Nomination Form
Anadromous Waters Catalog

Region Southwest USGS Quad(s) Kodiak C-2 SE
 Anadromous Waters Catalog Number of Waterway 259-24-10048
 Name of Waterway Unnamed Stream USGS Name Local Name
 Addition Deletion Correction Backup Information

Figure 1

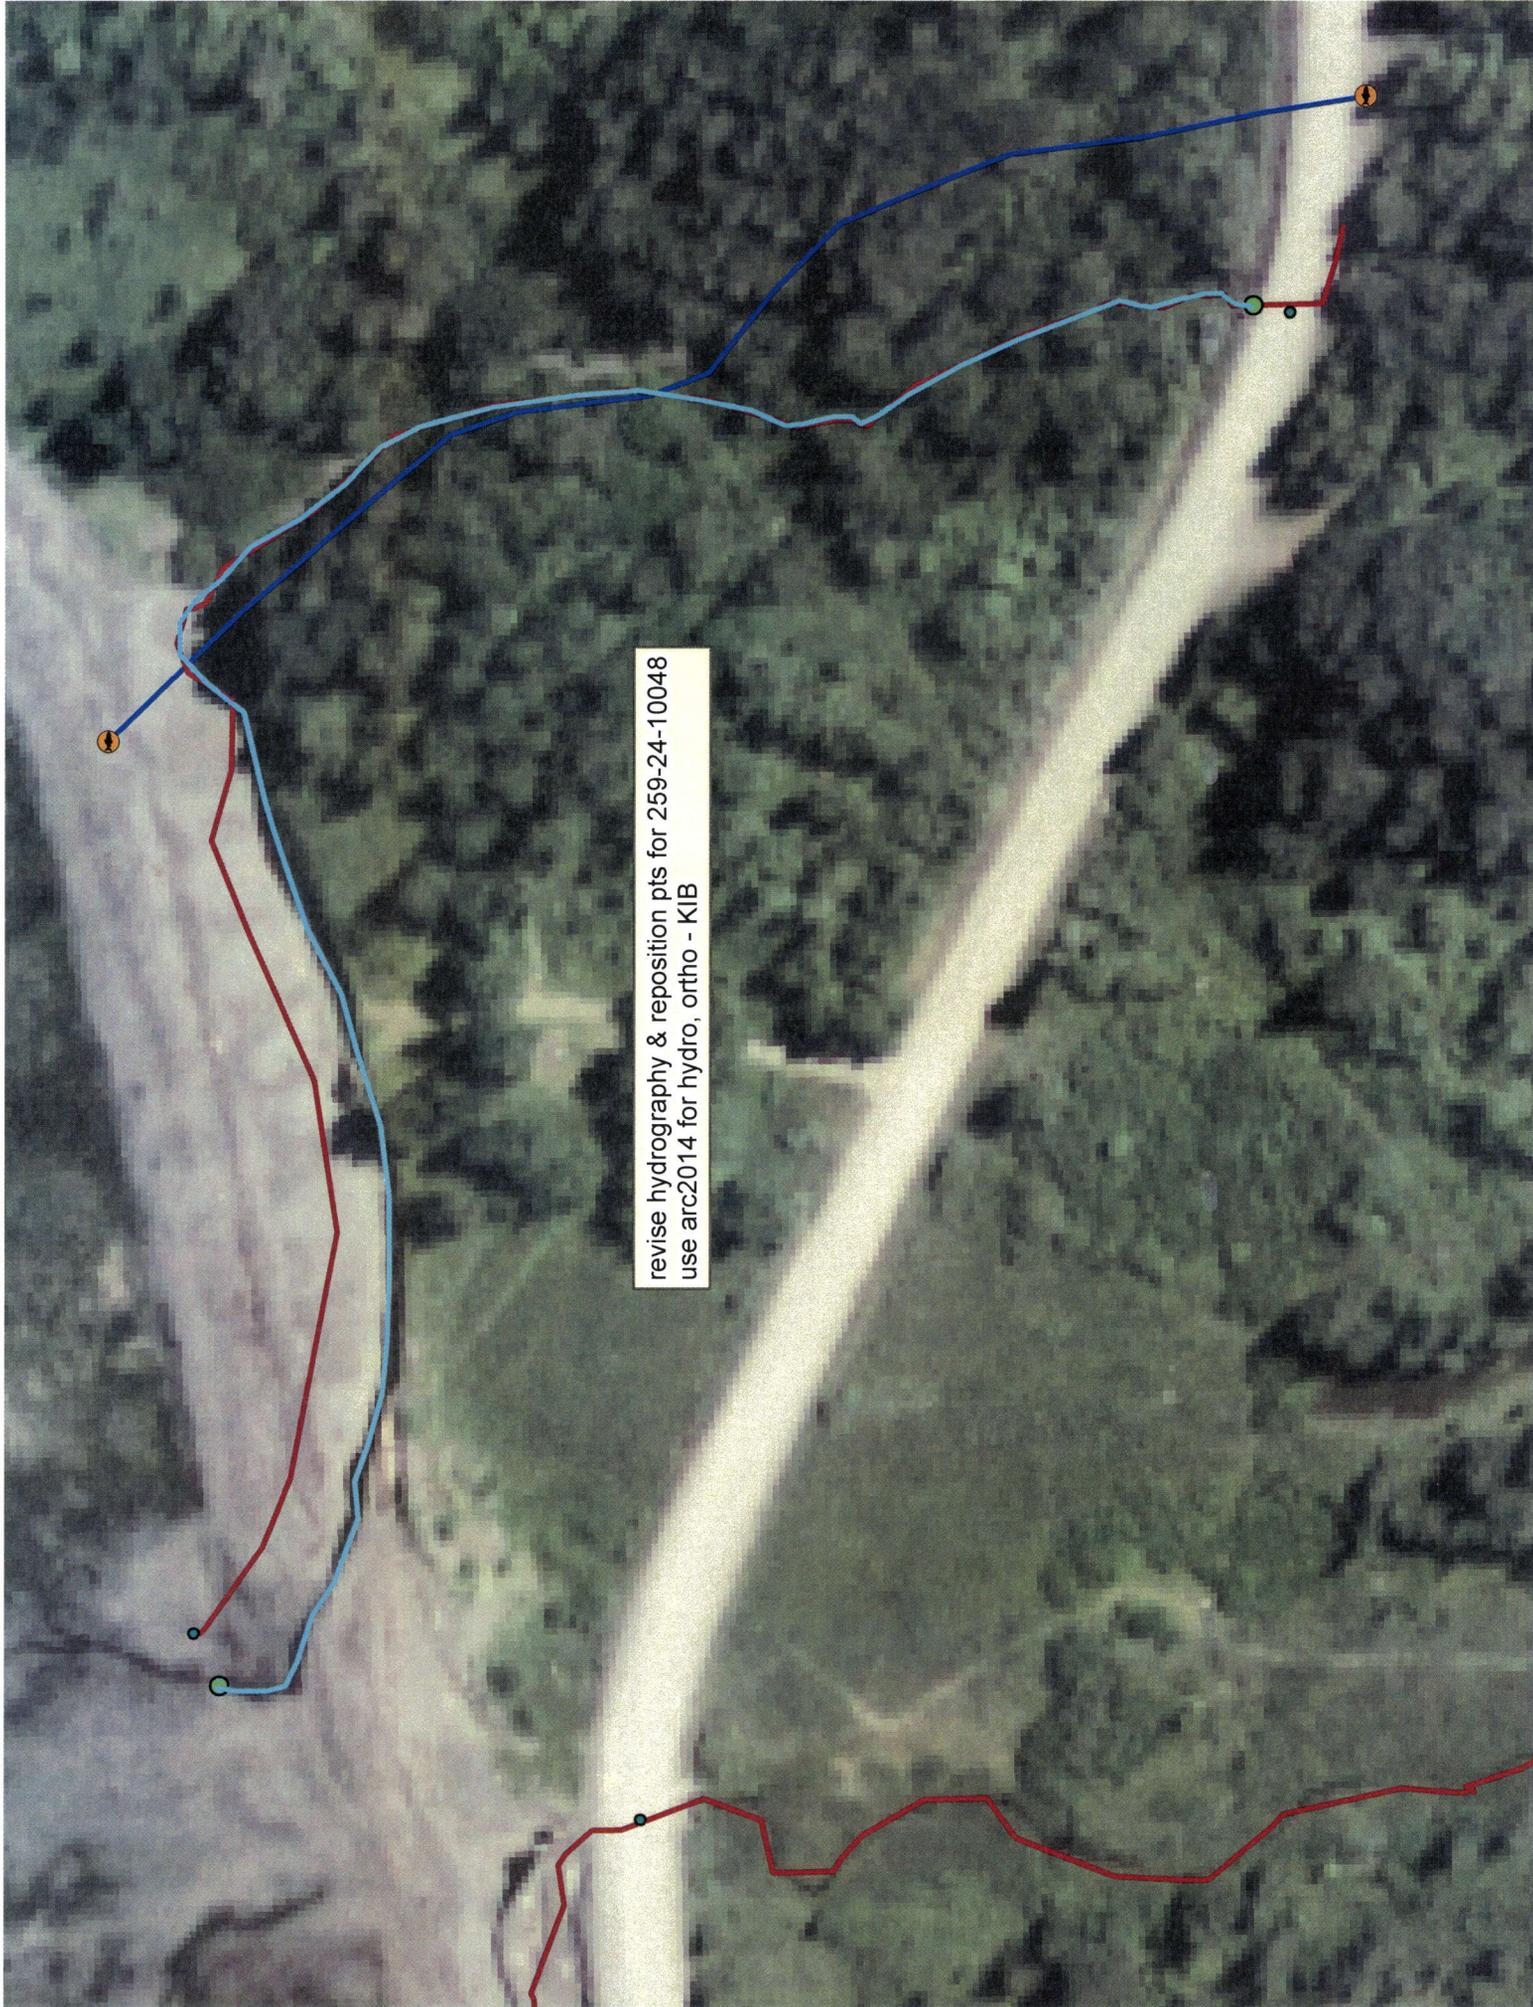
During a fish habitat survey I used a hand held Garmin GPS to correct the location of the unnamed stream (Figure 1). Upstream fish migration is blocked by two perched six-foot diameter culverts (CR-11).

revise hydrography & reposition pts for 259-24-10048
use arc2014 for hydro, ortho - KIB

Revise hydrography and reposition pts
